Improved Cylinder Head – 135 thru 220

ONE PIECE CYLINDER HEAD

220 Model
1987 and 1988
S/N 0B116662 thru 0C100860

135 thru 200 Models
1988 thru 1992
S/N 0B241881 thru 0D123402

Figure 1. One Piece Cylinder Head with New Protective Coating

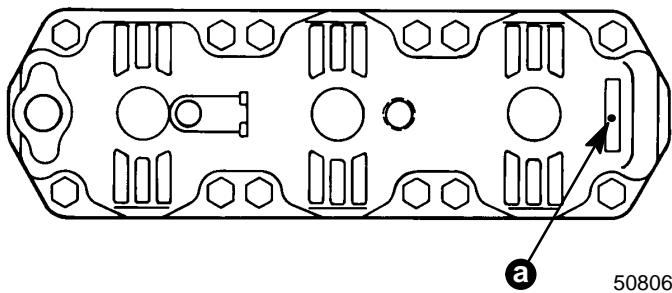
Mercury Marine has developed a new technology for applying an additional protective coating to the V6 one piece cylinder head. This coating greatly reduces salt water corrosion. These improved cylinder heads are installed on new V6 models and are available as a replacement part.

The improved heads have a drilled hole in the cast pad on the outer surface of the head to identify that the new coating has been applied.

Figure 2. Cylinder Head Sealing Surface

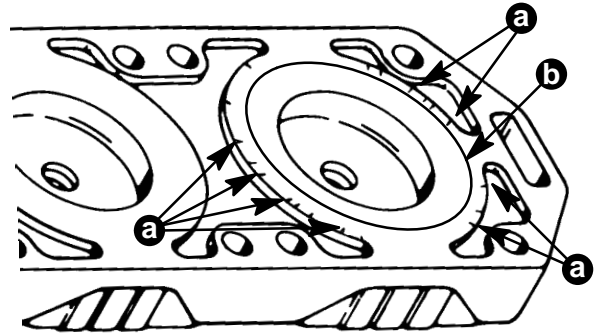
Whenever cylinder heads are removed on a salt water outboard, inspect for corrosion on the machined sealing surface. Visually inspect for corrosion that has started on the flat surface next to the water flow area and is progressing toward and under the head gasket fire ring sealing area. Replace with the improved cylinder heads if corrosion exists as described.

Figure 1. One Piece Cylinder Head with New Protective Coating

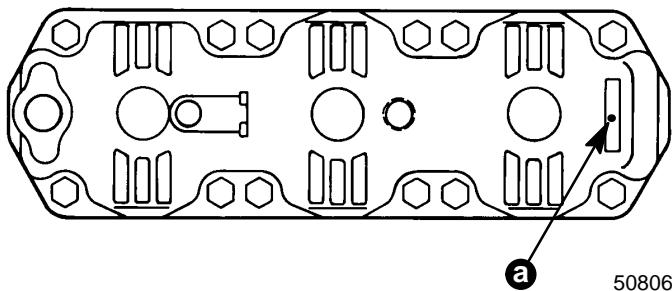
Mercury Marine has developed a new technology for applying an additional protective coating to the V6 one piece cylinder head. This coating greatly reduces salt water corrosion. These improved cylinder heads are installed on new V6 models and are available as a replacement part.

The improved heads have a drilled hole in the cast pad on the outer surface of the head to identify that the new coating has been applied.

Figure 2. Cylinder Head Sealing Surface

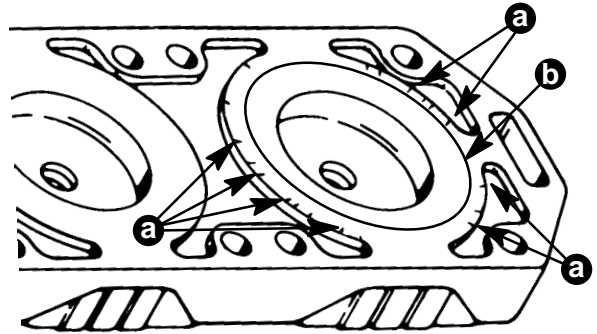
Whenever cylinder heads are removed on a salt water outboard, inspect for corrosion on the machined sealing surface. Visually inspect for corrosion that has started on the flat surface next to the water flow area and is progressing toward and under the head gasket fire ring sealing area. Replace with the improved cylinder heads if corrosion exists as described.
